**REGULAR MEETING
OF THE VINEYARD PLANNING COMMISSION,
Wednesday, June 16, 2021 at 6:00 p.m.**

4.2 Discussion and Action – 4Life Building Expansion Site Plan and Preliminary Plat

Date: June 16, 2021
From: Briam Amaya Perez, Planner II
To: Planning Commission
Item: 4Life Preliminary Plat and Site Plan
Address: 400 E 1600 N, Vineyard, Utah, 84059
Applicant: 4Life Properties LLC
Owner: Nate Buhler

ARCHITECTURAL SITE PLAN

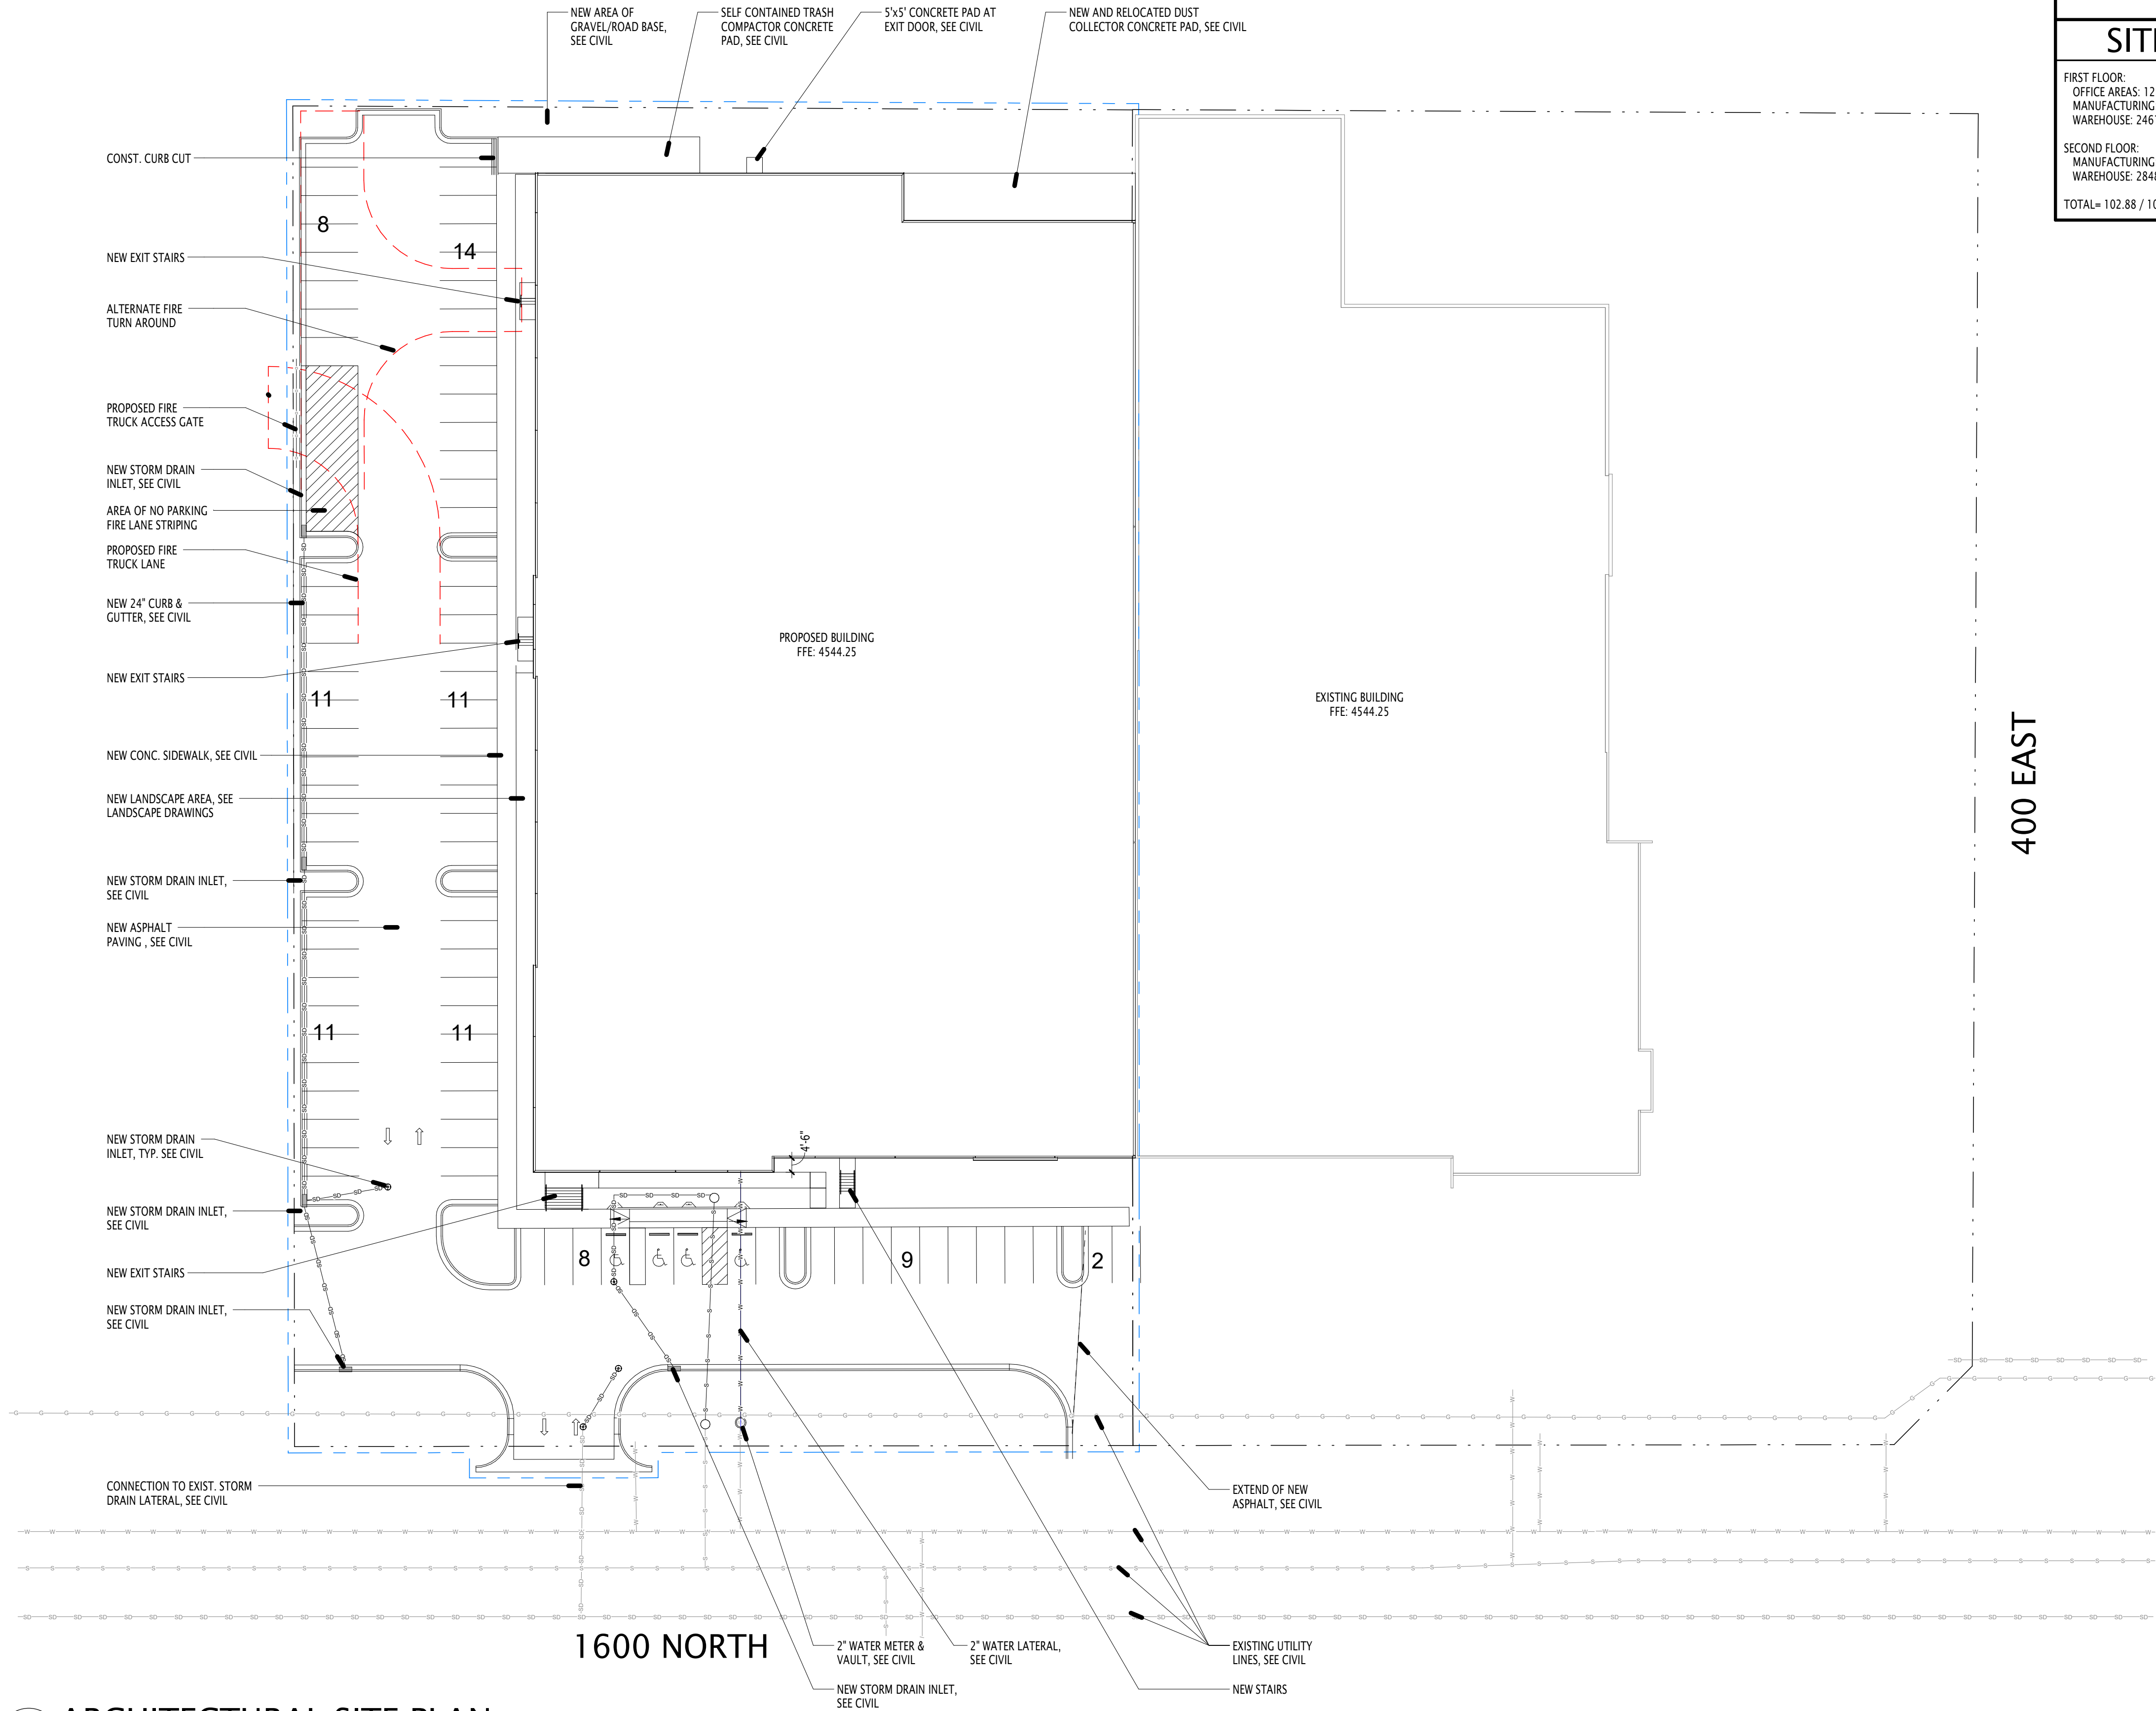
15.36.030.13.e Streetscape Landscape Treatments	All streetscapes shall create an attractive public space design and include street tree plantings, landscaping and other treatments and improvements, including consistency in street lighting, pedestrian lighting, public art and pedestrian and biking facilities and street furniture.	Where will you locate biking parking?	☐ Yes ☒ No ☐ N/A

parking stalls shall be marked with painted lines not less than 4" wide		☐ No ☐ N/A
15.38.030.1.l. Lighting	Parking lots used during hours of darkness shall be illuminated. Any lighting used to illuminate an off-street parking area shall be so arranged as to reflect the light down and/or away from adjoining property, abutting residential uses and public rights-of-way and shall be a maximum of 20 feet in height above the surface parking for non-residential uses and 16 feet for residential uses.	Please provide a lighting strategy. Lighting is not clearly labeled on the site plan.	☒ Yes ☐ No ☐ N/A

15.38.030.1.n. Screening	All off-street parking lots of 4 or more spaces shall be screened from the street view and adjacent residential districts by a landscaped berm, decorative wall, vertical landscaping, or combination there-of at 3 feet high, as measured at finished grade adjacent to the parking area to be screened. All walls or berms shall be installed a minimum of 2.5 feet back from the edge of the parking stall.	Please provide a consistent 3' tall screening element.	☒ Yes ☐ No ☐ N/A

15.38.040.2.h. Bicycle Parking	Required bicycle parking shall be convenient, secure, and readily accessible to shoppers, customers, visitors, employees, students, residents, commuters, and others on the site.	No bicycle parking is currently indicated on the site plan.	☐ Yes ☒ No ☐ N/A

15.38.040.2.h.i. Bicycle Parking	Required Bicycle Parking Spaces: Bicycle parking spaces shall be required in all zones for each site to which this Title applies. The number	No bicycle parking is currently indicated on the site plan.	☐ Yes ☒ No ☐ N/A

NORTH ELEVATION

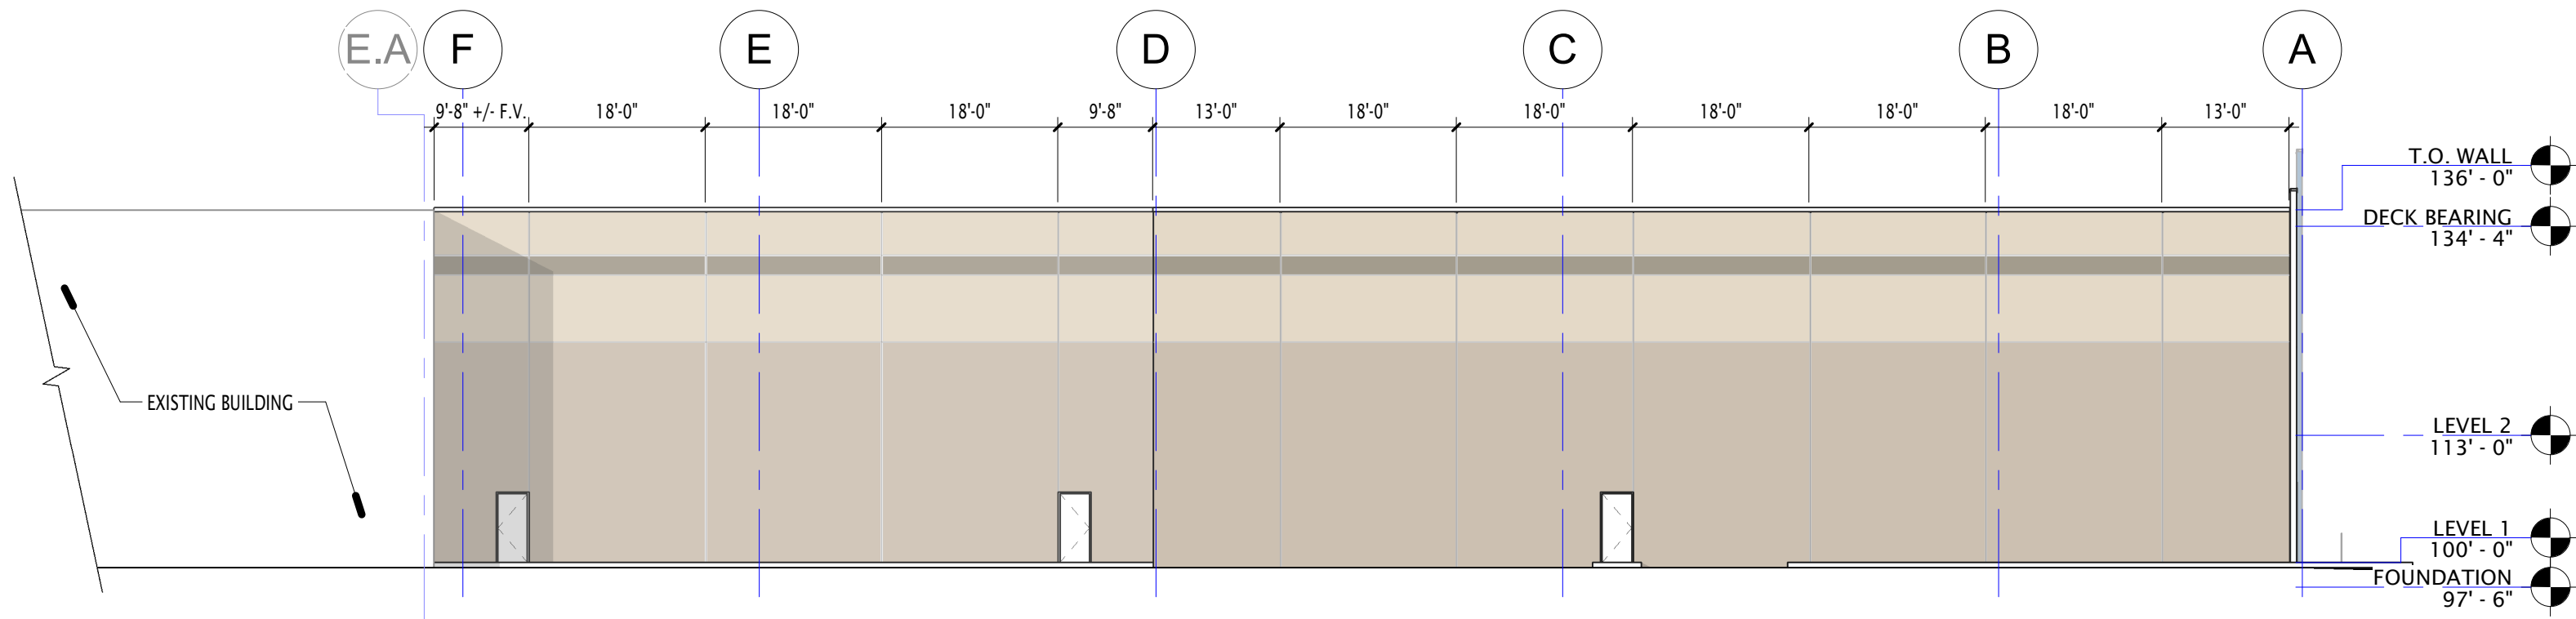
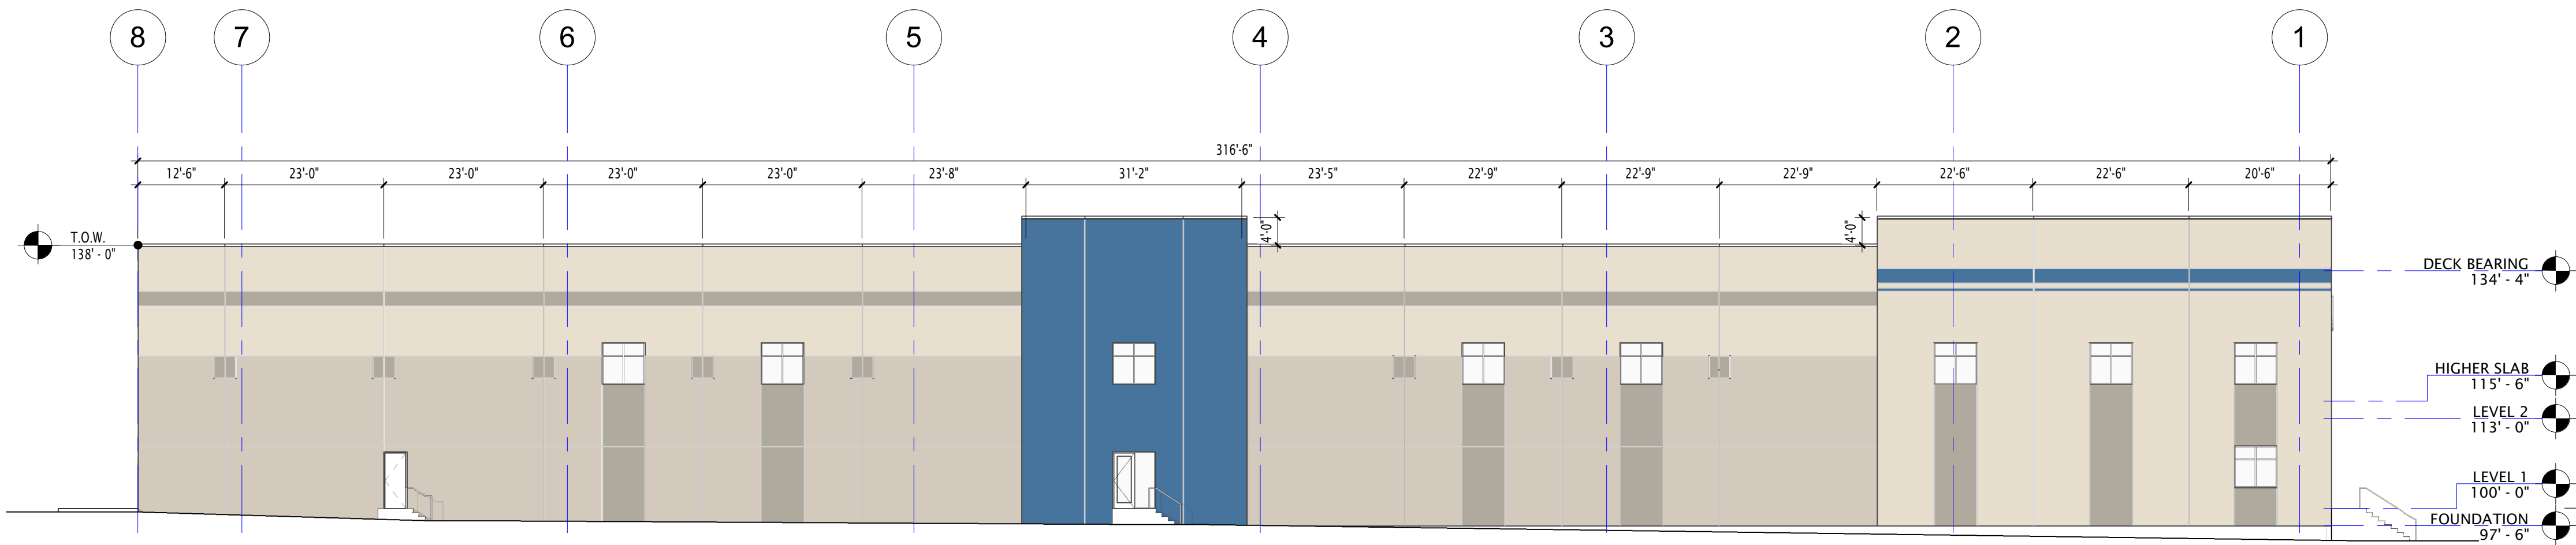
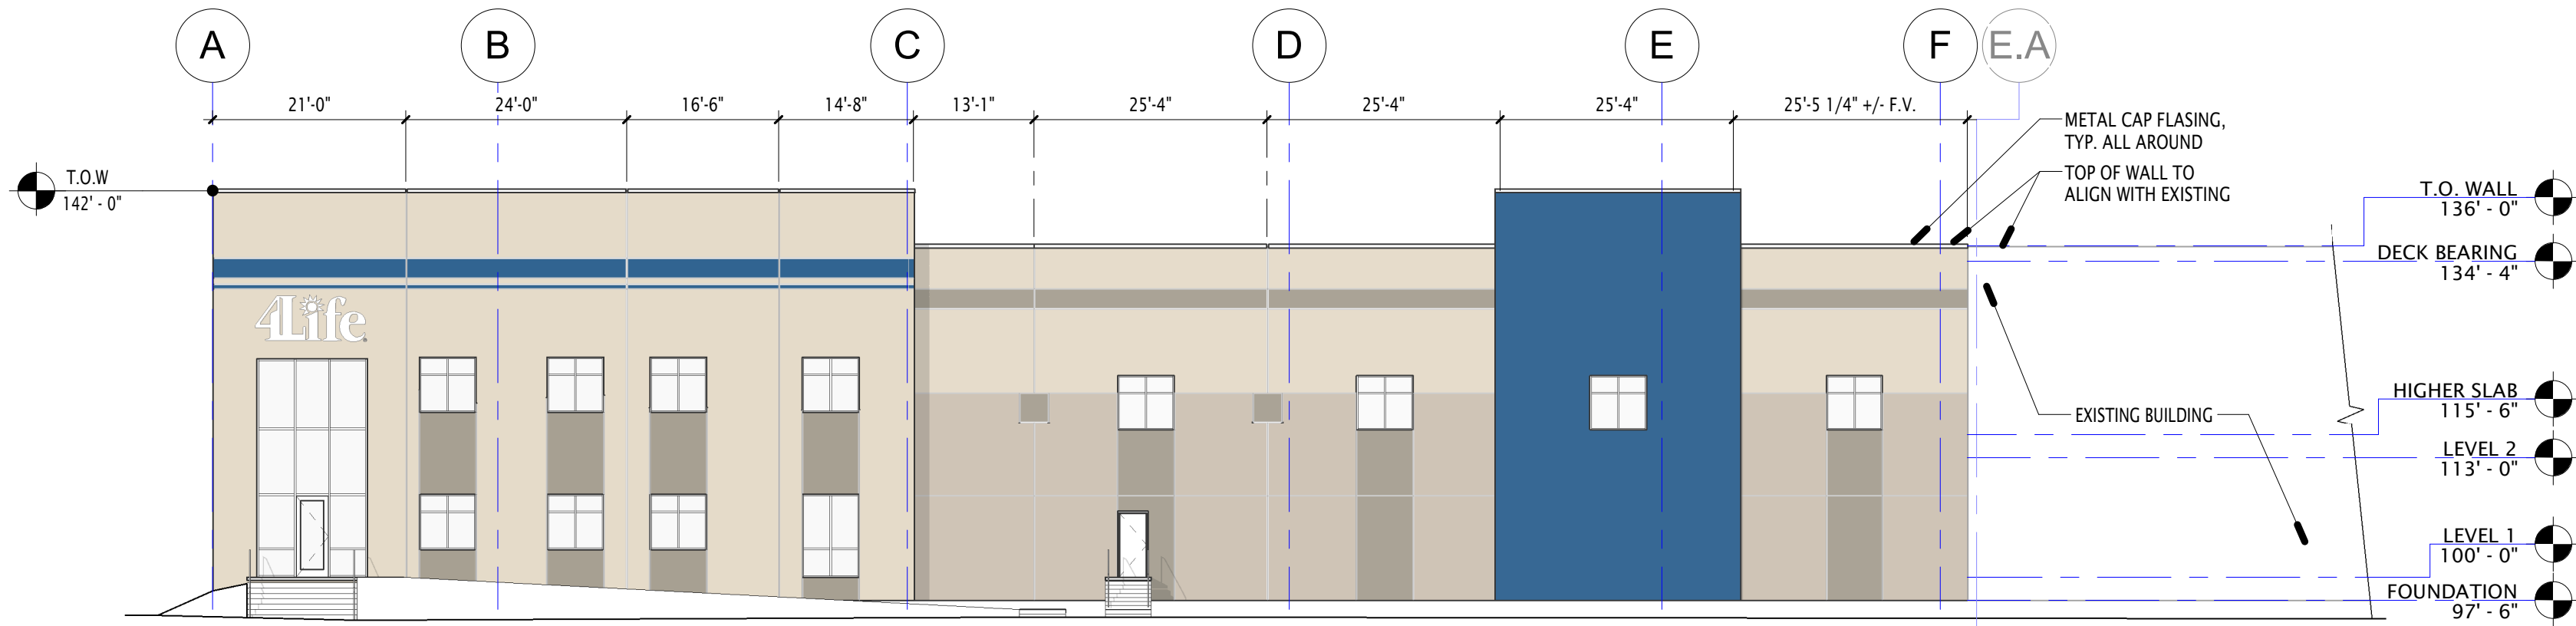
15.36.030.1.a.ii.2	Continuous building wall surfaces shall be relieved with variations of wall planes or overhangs that create shadow areas and add visual interest .	The proposed building DOES NOT meet these requirements. Please explain how your proposal meets these requirements.	☐ Yes ☒ No ☐ N/A

15.36.030.1.a.v Architectural details	Surface details, ornaments, and other building elements that enrich the character of a building are encouraged. Attention to detail, including all building and architectural design elements shall be required. The following architectural details are desirable and encouraged: - Stonework - Exposed beams and columns - Cornices, moldings, bands, pop-outs, decorative vents, cast or sculpted features - Covered entries, patios, walkways, breezeways, bays, and balconies - Enclosed courtyards and patios, trellises, landscape areas and wide roof overhangs - Accessories such as art features, benches, pots, lamps, artwork, and sculptures.	The proposed building DOES NOT meet these requirements. Please explain how your proposal meets these requirements.	☐ Yes ☒ No ☐ N/A
